SERVICE BULLETIN # 1023

SUBJECT Outboard Handle and Bars.

MODEL ALL (Except 5-49, 7-55 & 99 DATE 6-13-58

This template drawing will assist in the correct location of the mounting holes.

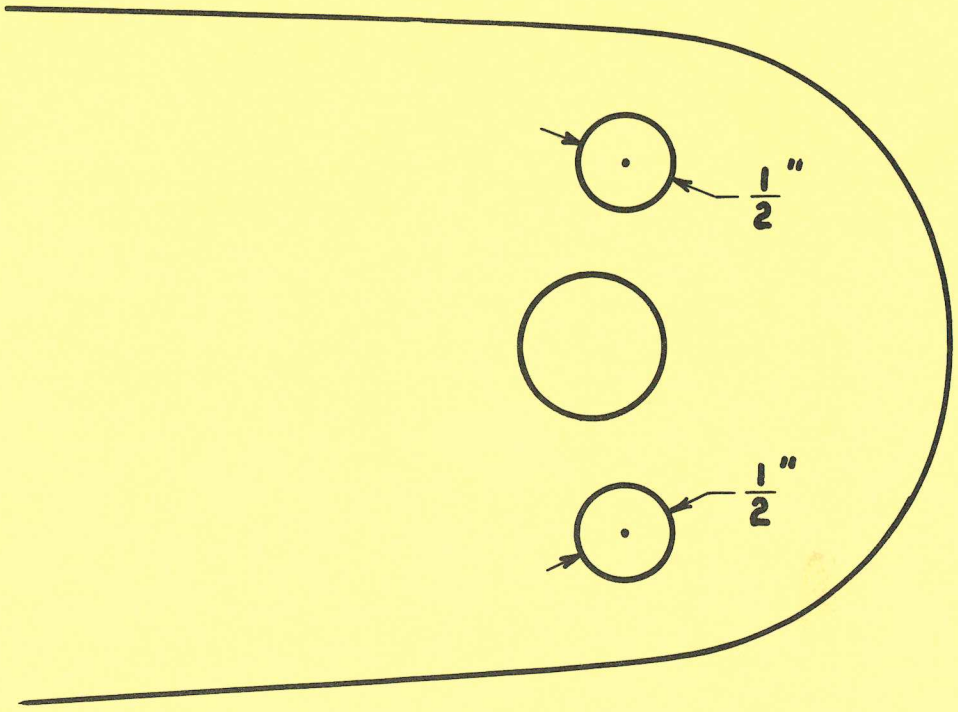
The following list of chain saw bars can be used with the outboard handle assembly, part number 19937, when the bars have been drilled with two additional holes to accommodate the handle bosses:

NOTE: If the mounting holes are mislocated slightly so that one breaks through into the chain groove, no damage to chain tangs will result since the handle bosses are made of the relatively soft aluminum.
